State of New Mexico
Energy, Minerals and Natural Resources Department

SUNDRY NOTICES AND REPORTS ON WELLS

8. Well Name and No.
Richardson 102S

Energen Resources would like to request the following changes to the Richardson #102S.

WELL LOCATION AND ACREAGE DEDICATION PLAT

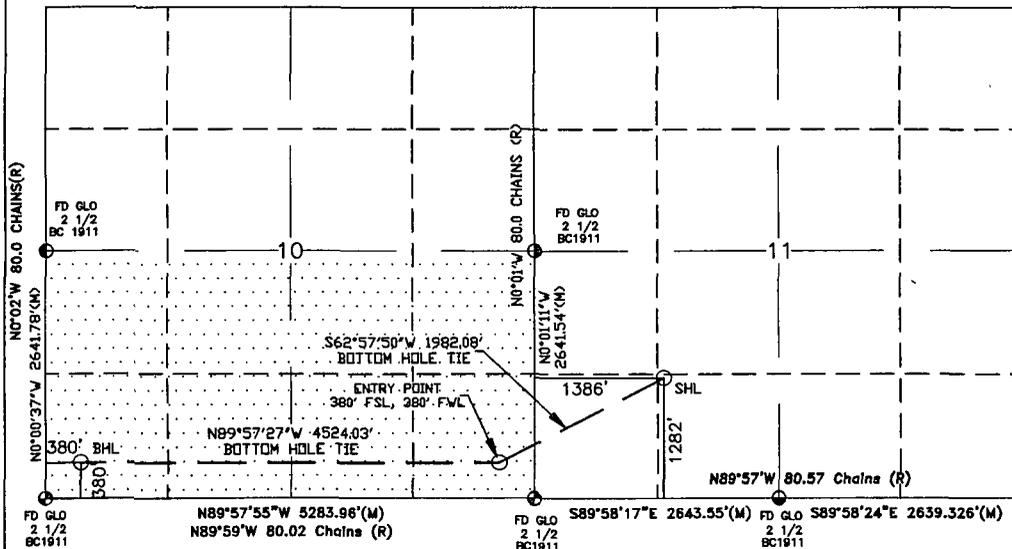
- * Change the name of the well from the Richardson #102S to the Richardson Navajo 27-13-10 #4H.
- * Change the target formation from the Basin Fruitland Coal (71629) to the Basin Mancos (97232).
- * Change the drilling plan from a vertical drill to a horizontal drill with the bottom hole at Sec 10 T27N R13W, 380' FSL 380' FWL (M) SW/SW as indicated on the attached C-102.

Plan #1

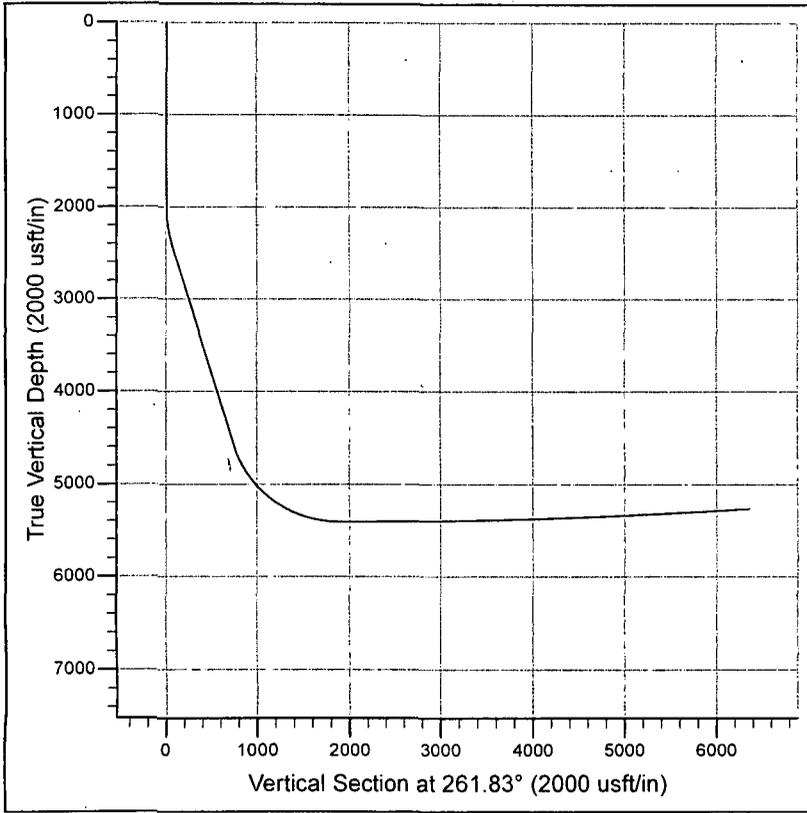
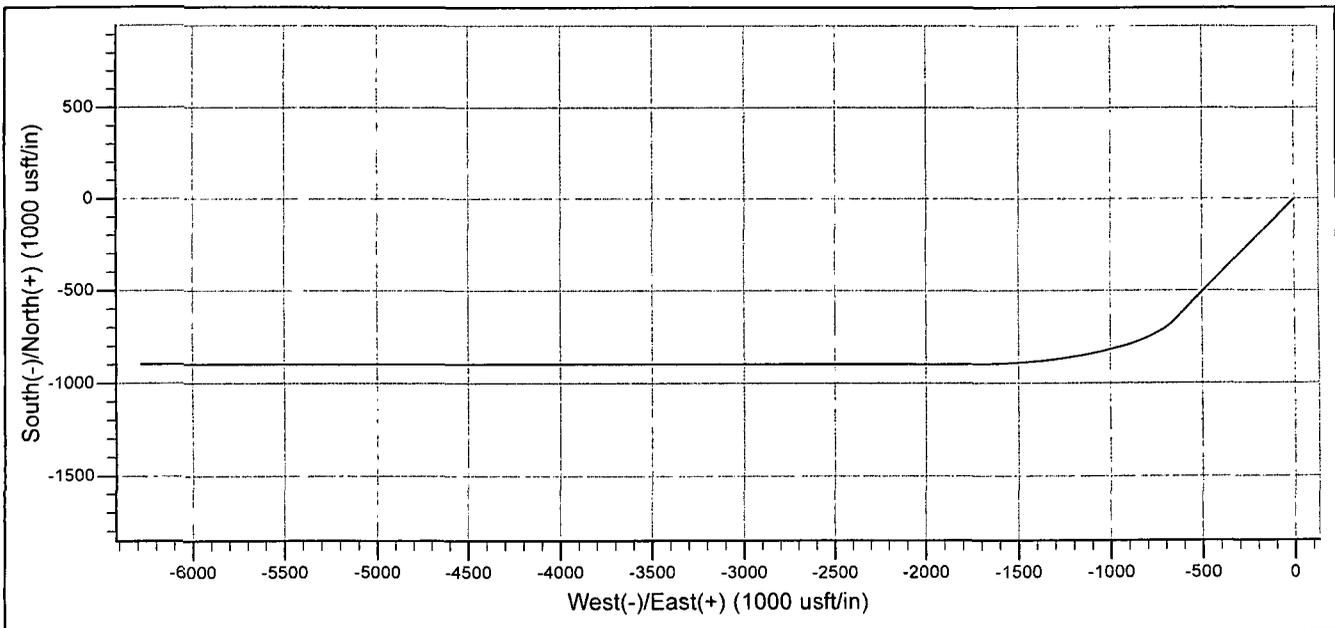
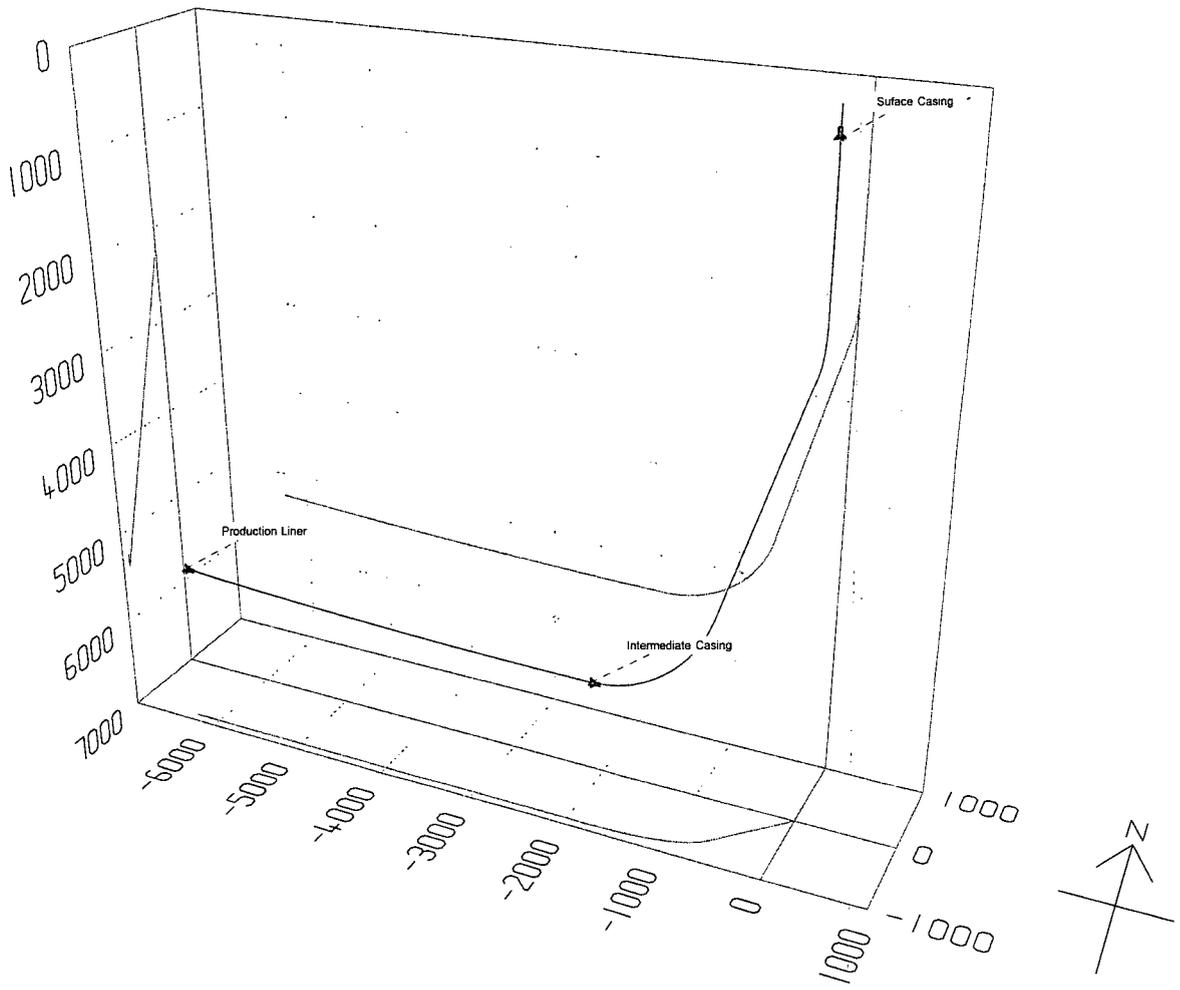
the new drilling plans depicting the casing changes along with the directional design is attached showing the revisions.
